Resolution CARPC No. 2011-5

Amending the *Dane County Land Use and Transportation Plan* and *Dane County Water Quality Plan* by Revising the Stoughton Urban Service Area Boundary and Environmental Corridors in the West End Neighborhood in the City of Stoughton and Town of Rutland

Map 1 West End Development
 Amendment to the Stoughton Urban Service Area and Environmental Corridors in the City of Stoughton and Town of Rutland

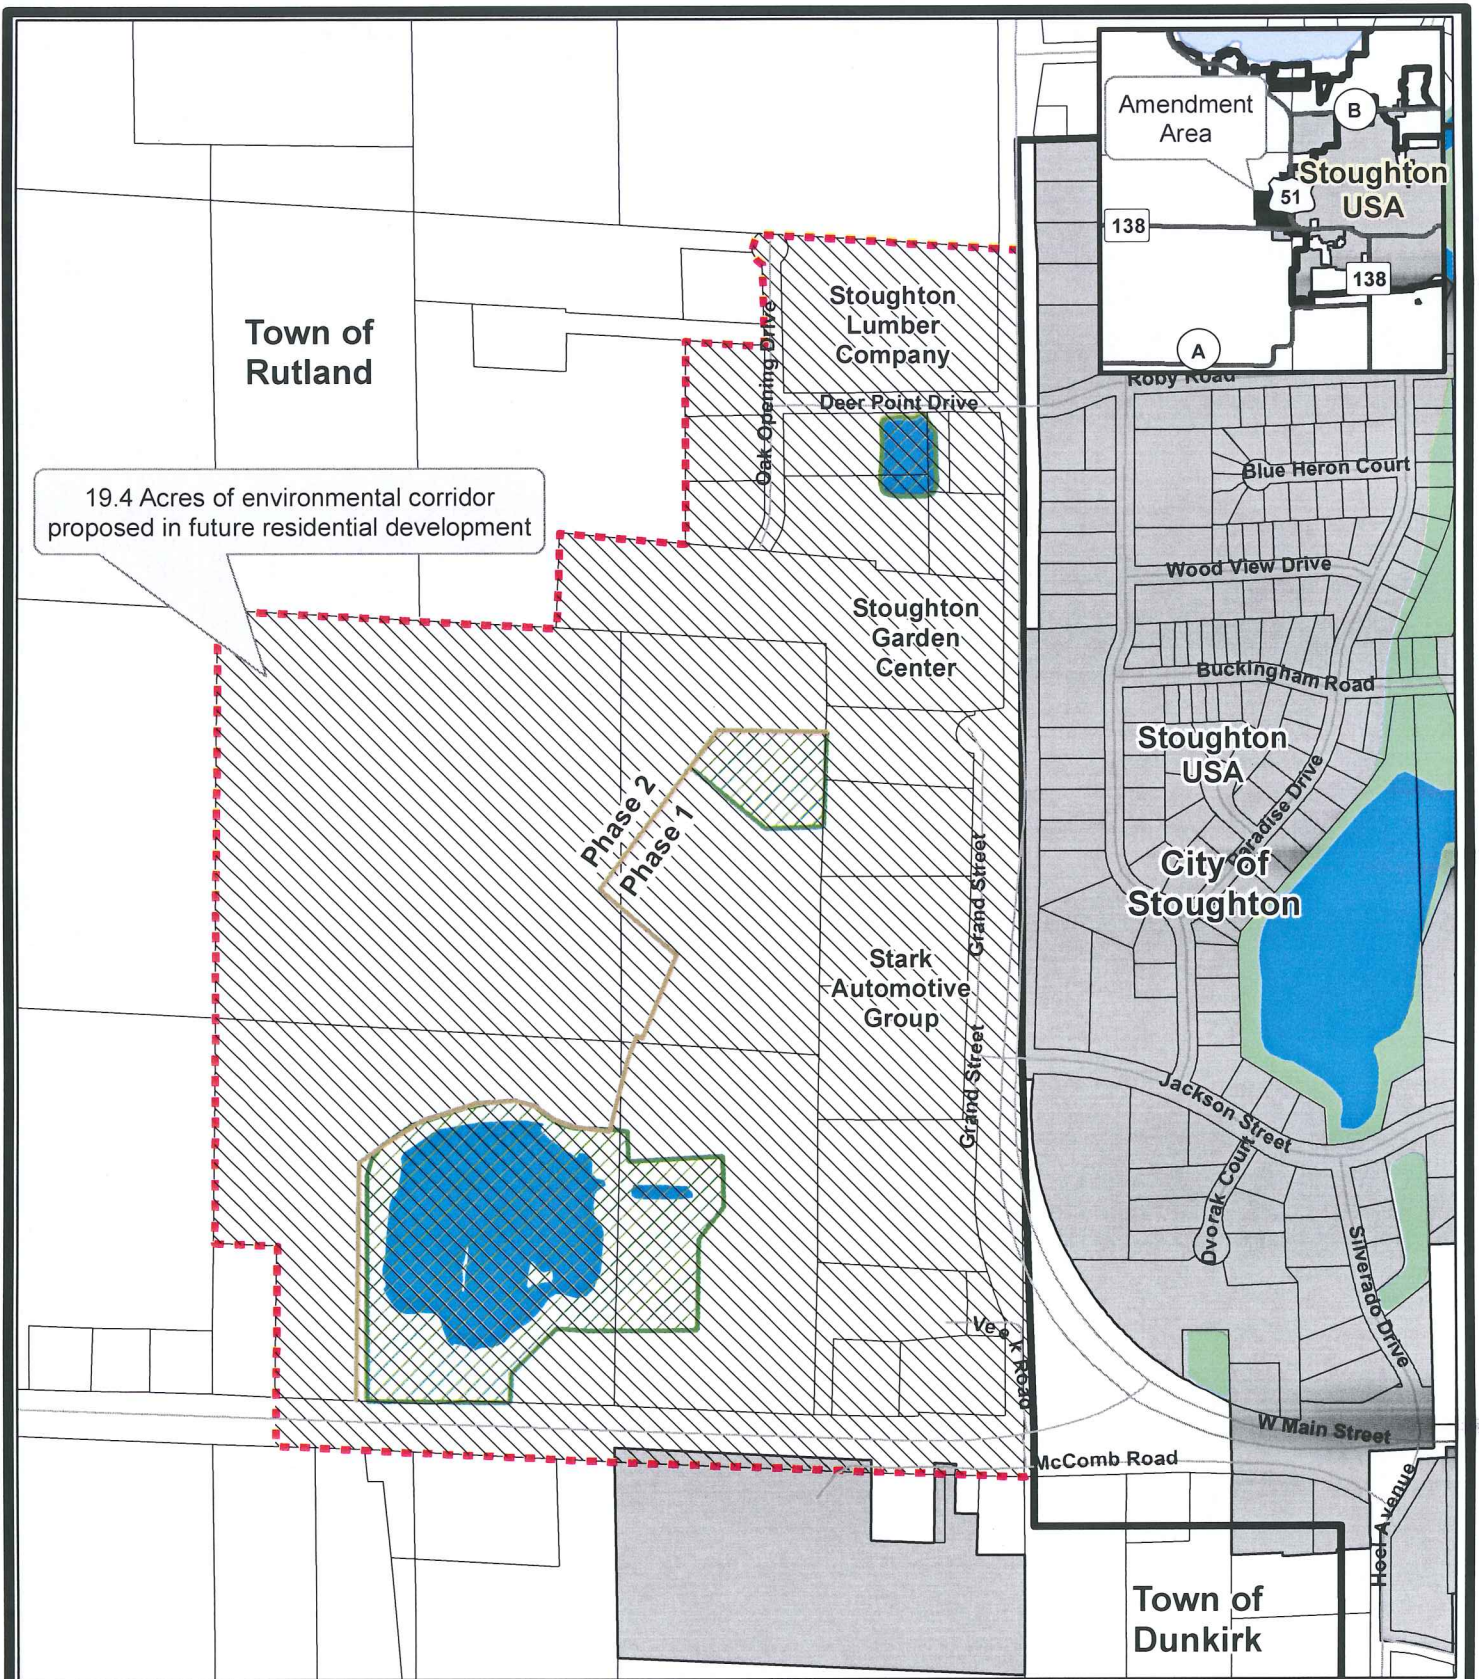
NOW, THEREFORE, BE IT RESOLVED that in accordance with §66.0309, Wis. Stats., and Sec. 208 of Public Law 92-500, the Capital Area Regional Planning Commission amends the *Dane County Land Use and Transportation Plan* and recommends the amendment of the *Dane County Water Quality Plan* by revising the Stoughton Urban Service Area boundary and environmental corridors as shown on the attached map.

1. Submit a detailed stormwater management plan for CARPC and DCL&WCD staff review and approval prior to any land disturbing activities in the amendment area. The stormwater management plan will include the following:

- b. Control peak rates of runoff for the 1, 2, 10, and 100-year 24-hour design storms for each phase to “pre-development” levels (i.e. maximum Runoff Curve Number = 68 for agricultural land use and hydrologic soil group B) prior to discharge to the wetland.

- c. Maintain the post development stay-on volume to at least 90% of the pre-development stay-on volume for the one-year average annual rainfall period, as defined by WDNR prior to discharge to the wetland.

- d. Maintain the post development stay-on volume of 100% of the pre-development stay-on volume for up to and including the 100-year 24-hour design storm prior to discharge from the amendment area to maintain the current closed basin hydrology.

- e. Provide an emergency outlet for the closed basin to safely pass the 100-year 24-hour storm in the event of system failure. The timing of the construction of this outlet will be determined based on the detailed stormwater design of each phase. It may be possible to postpone the construction of the emergency outlet to a subsequent phase of the proposed development, based on City of Stoughton, CARPC and DCL&WCD staff review of the stormwater design.

- f. Maintain suitable wetland hydrology by controlling the wetland water level bounce for the 1-, 2-, and 10-year, 24-hour design storms to within 0.5 feet of existing conditions and providing a maximum drawdown time in the wetland to within 24-hours of existing conditions for the 1- and 2-year, 24-hour storms and within 72-hours of existing conditions for the 10- and 100-year, 24-hour storms.

2. All stormwater management facilities will be designated as environmental corridors, and stormwater easements will be provide for the facilities. Final environmental corridor delineations will be based on CARPC criteria and wetland delineations.

4. The conceptual plan shows multiple driveway access points to the commercial center from STH 138. Access to this arterial roadway should be limited to one or two streets with no driveway access to maintain good traffic flow and safety in the future.
